September 26, 2008 Subject: **Can-Am™ DS 450™ New Clutch Parts**

No. **2009-9**

NEW CLUTCH PARTS

CLUTCH HUB

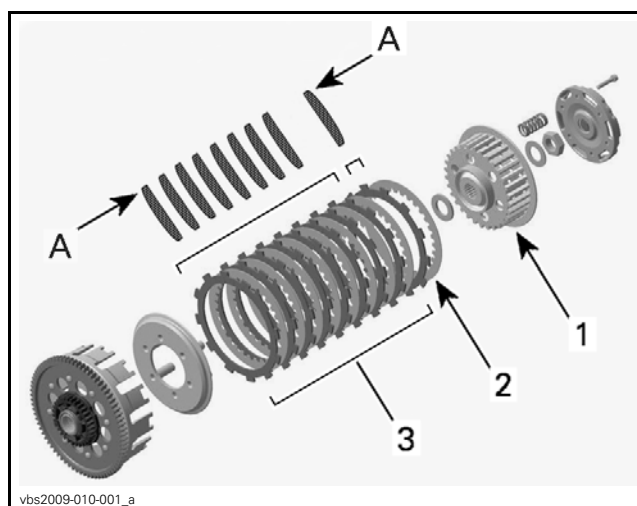
The new clutch hub has different machining and requires an extra clutch plate (9 instead of 8) that is seated against the clutch hub itself.

A. Increased dimension for the new clutch hub

The extra clutch plate is the same as the other clutch plates and is to be seated with the rounded edge toward the clutch hub. It is also recommended that the other clutch plates be inverted and installed toward the clutch drum.

A. Rounded edge

1. New clutch hub
2. Additional clutch plate
3. Other clutch plates

CLUTCH COVER

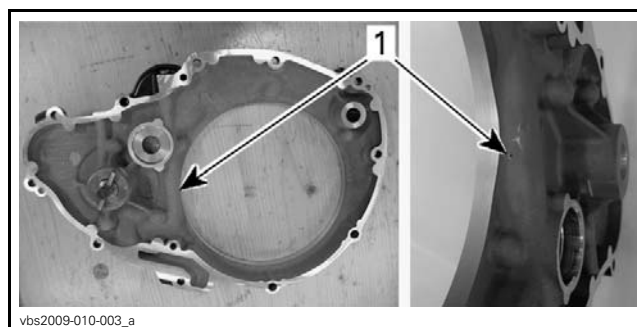
The new clutch cover has a small calibrated hole drilled into an oil passageway. This will allow oil to fog the inside of the clutch area.

1. Small calibrated hole
